CERTIFICATE OF APPROPRIATENESS

**RE: Application Number 20-6987; 2447 Cass; Cass-Henry Historic District
Project Scope: Rehabilitate Apartment Building**

RE: 2447 Cass Avenue—Hotel Ansonia/Grande Apartments

2447 CASS FLOOR PLAN 2-4
 2
 7A101
 1/8" = 1'-0"
 PROJECT NORTH

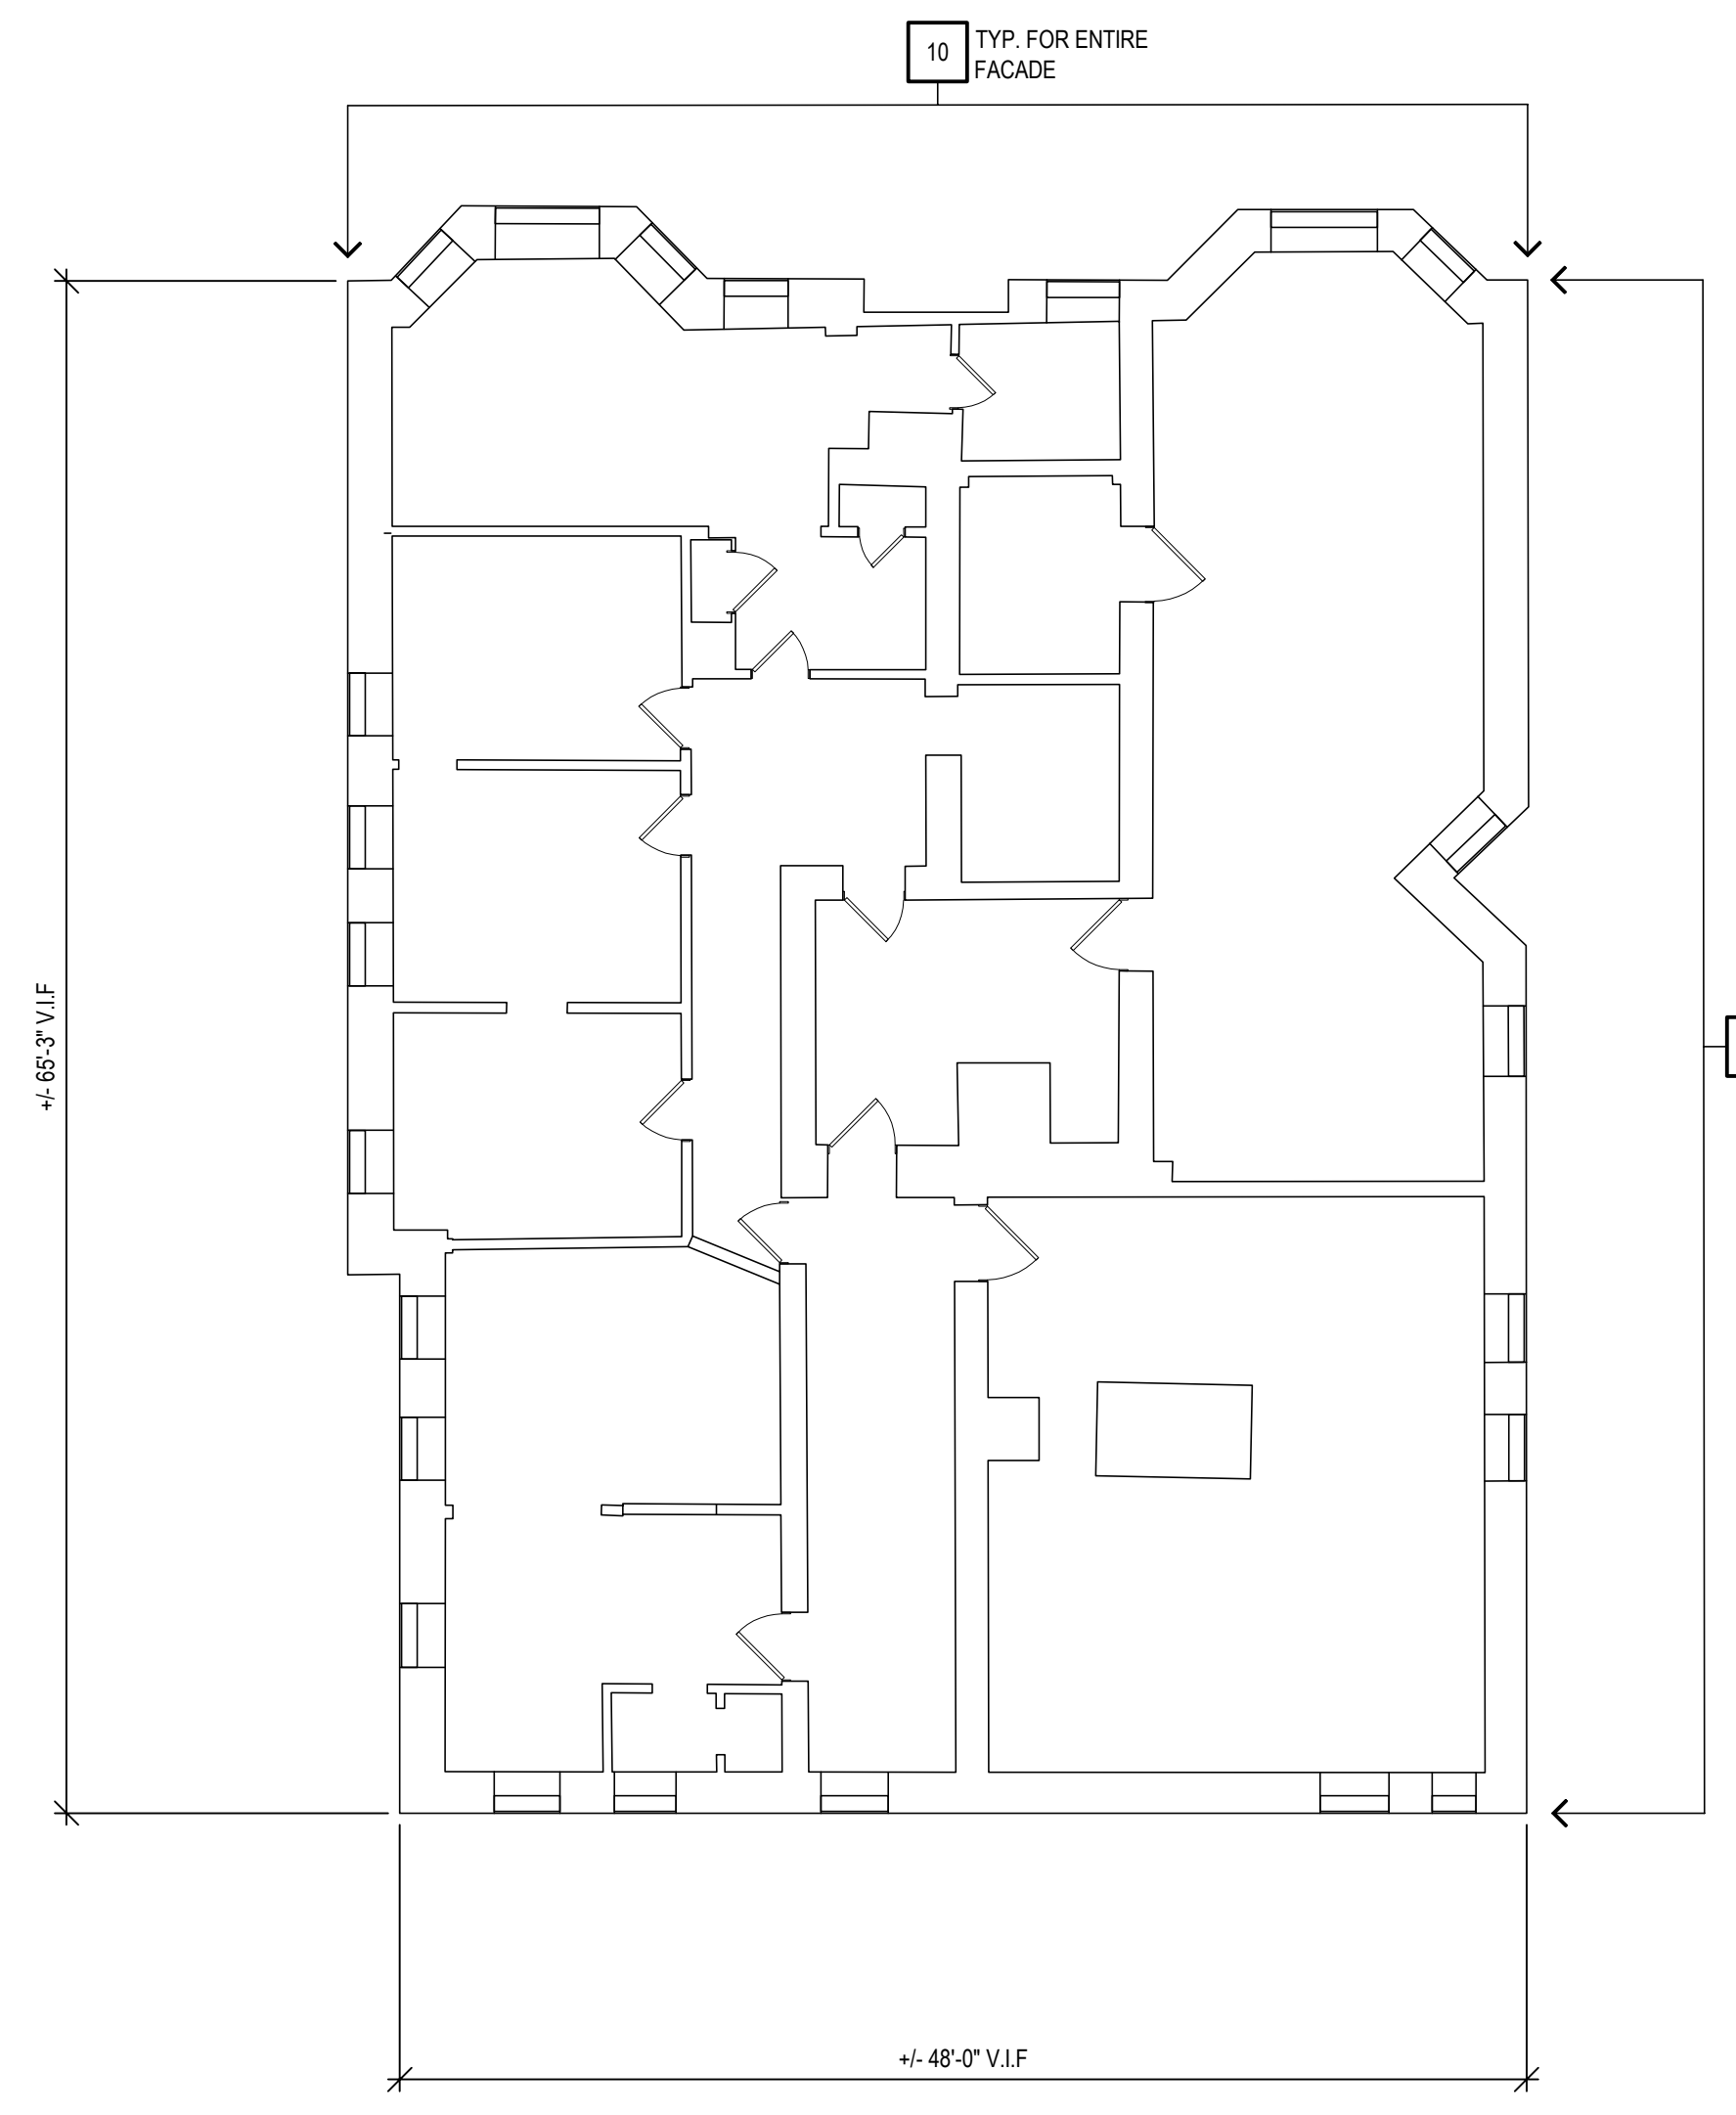
- *Current EPDM roof to be removed and replaced with a new EPDM roof*
- *Small condensers will be added to the center and western side of the roof with painted metal panel mechanical screens to obscure the condensers*
- *Small skylight in center of roof to be removed and replaced with a contemporary low-profile skylight structure*

And, as per the submitted documents, specifically drawings 7A101 (floor/roof plans) and 7A401, 7A401.1 (elevations).

- Staff review of the submitted construction drawings will include the identification of specific standards concerning repair and/or replacement of deteriorated character-defining features, and related standards concerning the qualifications of historic preservation contractors retained to perform the work.
- Staff review of the submitted construction drawings to specifically include review of specifications/cut sheets for lighting, windows, doors, ADA lifts, signage, paint removal, paint colors, and other exterior elements/selections not yet finalized, with staff authority to approve if per the Secretary of the Interior's Standards, the district's Elements of Design, and otherwise consistent with Commission intent and guidelines.

Sheet
7A401

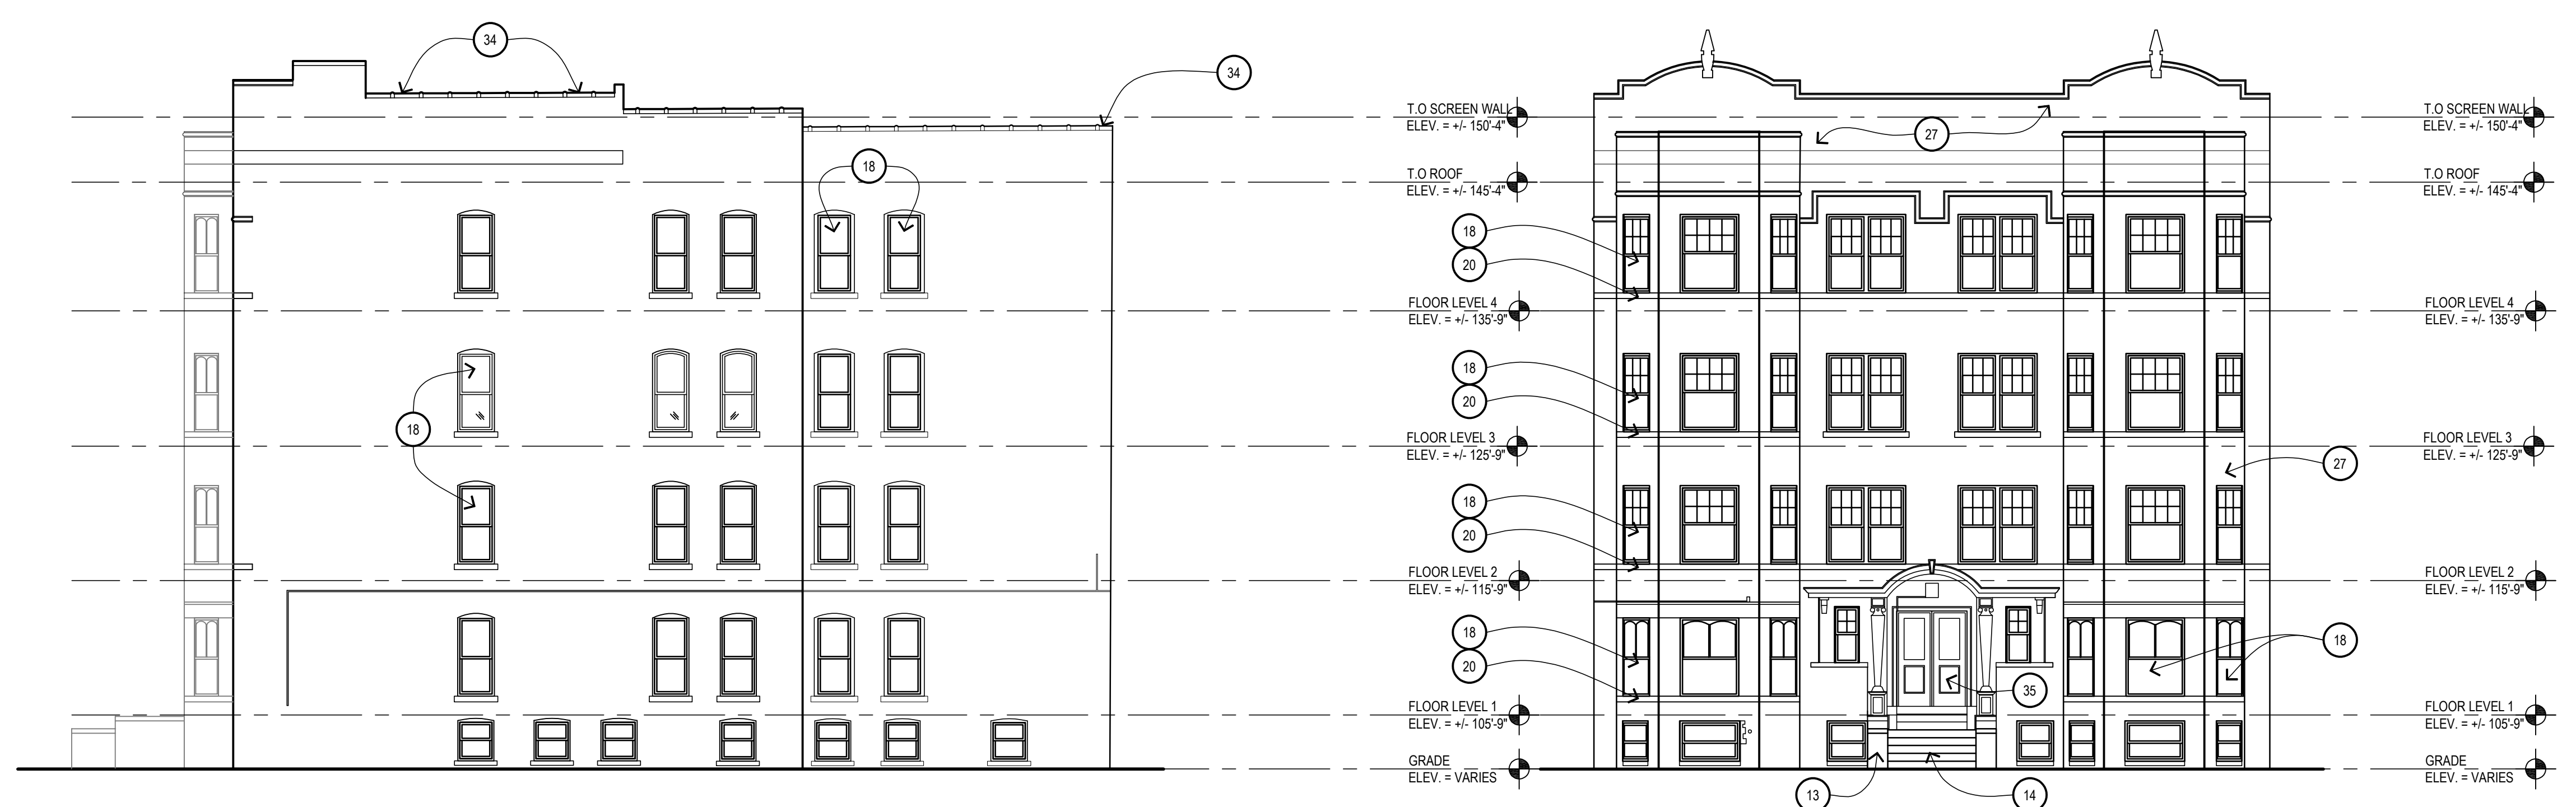
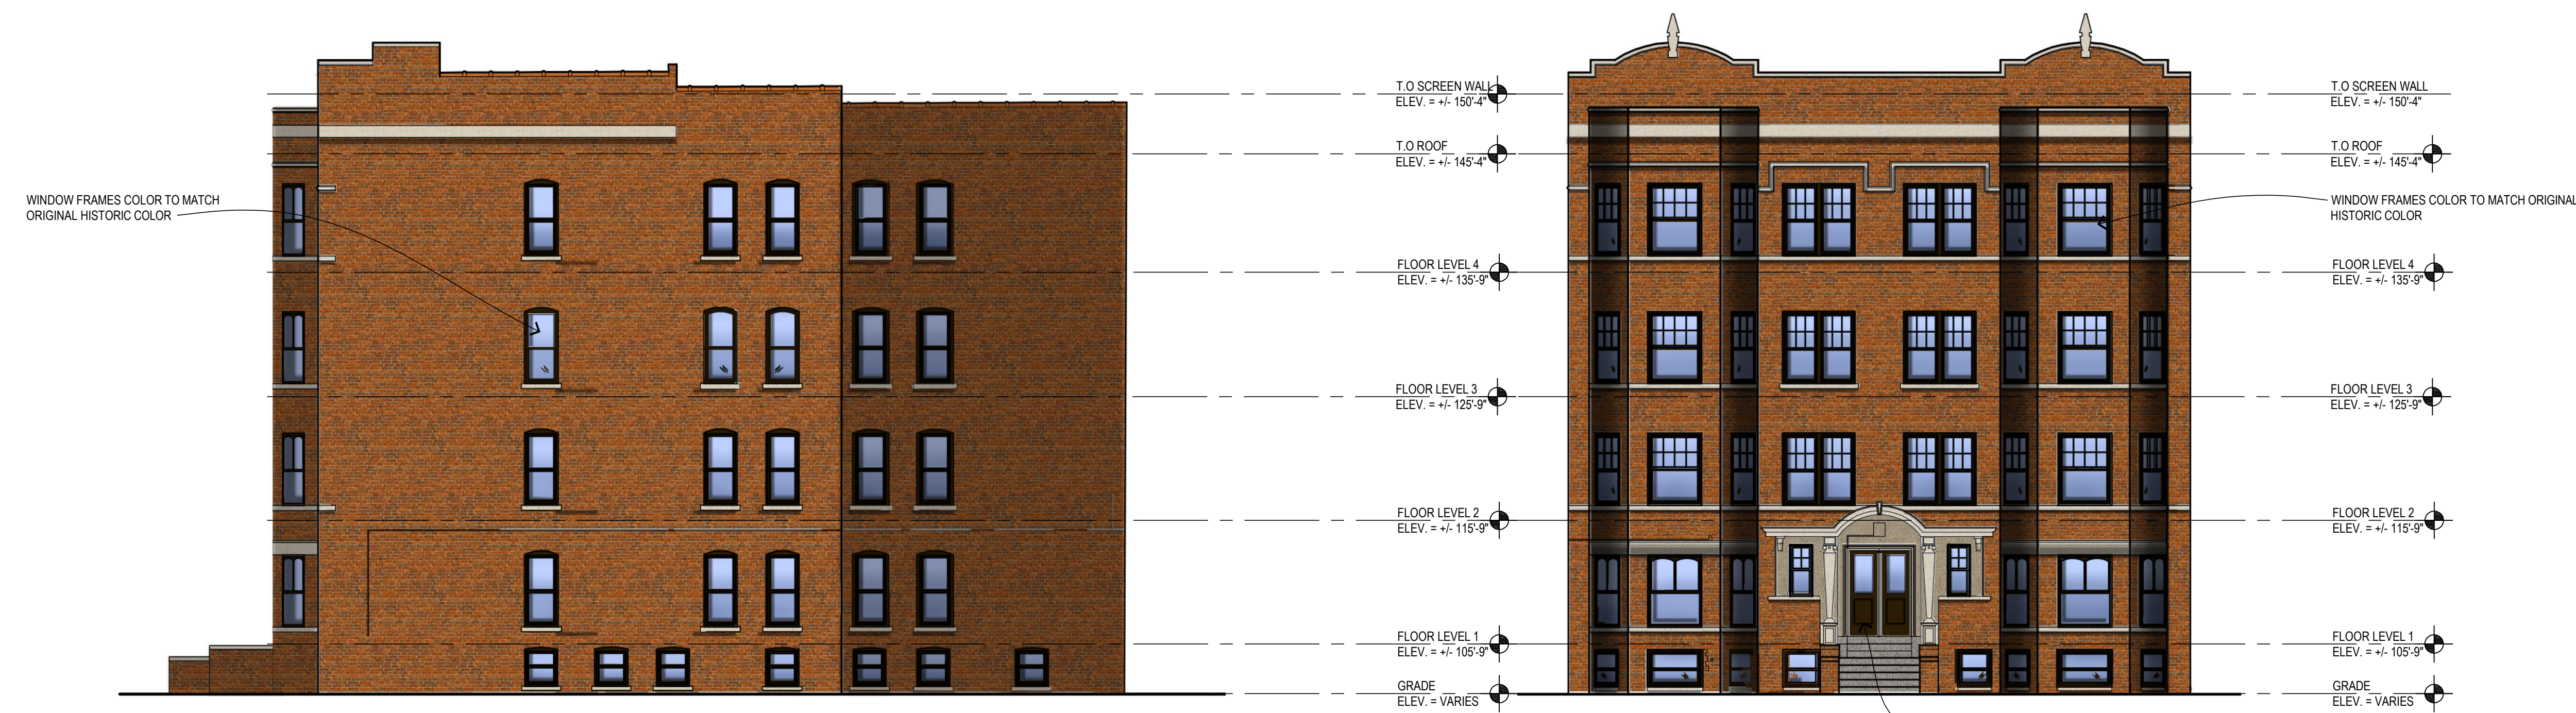
- *Inspected for damage*
- *Brown paint to be removed (process not provided)*
- *Masonry cleaned with a light duty detergent and low pressure water rinse*
- *Brick and stone will be repointed, and loose or displaced units will be reset*
- *Repointed mortar will match the color, texture, compressive strength, joint width, and joint profile of the existing historic mortar*
- *Damaged brick and stone will be repaired as necessary*
- *Any units too badly deteriorated to repair will be replaced, with salvaged brick to be reused where replacements are needed before new units are used*
- *If new units are necessary, they will be selected to match the existing in size, profile, color, and finish*

- *Remove existing concrete masonry units (CMU)*
- *Install a new glazed wood double door compatible with the historic nature of the building (color TBD)*
- *New solid doors in the west elevation at the fire escape (material/design TBD)*
- *ADA lift to be installed on the back of the building to access the first floor fire escape to provide ADA access to the first floor units*

- *New historic replica aluminum-clad wood windows throughout: Marvin Ultimate Double Hung G2 per attached data sheet (no extant historic windows, dark color TBD)*
- *On primary (east) façade, first floor, windows will be 2/1 except the two windows flanking the entrance which will be further researched to determine their design*
- *On primary (east) façade, upper floors, windows will be 6/1 on the outer bay window openings and in the two central bays of the building. The center bay window openings will have 8/1 units.*
- *1/1 single hung units will be used on the remaining windows*
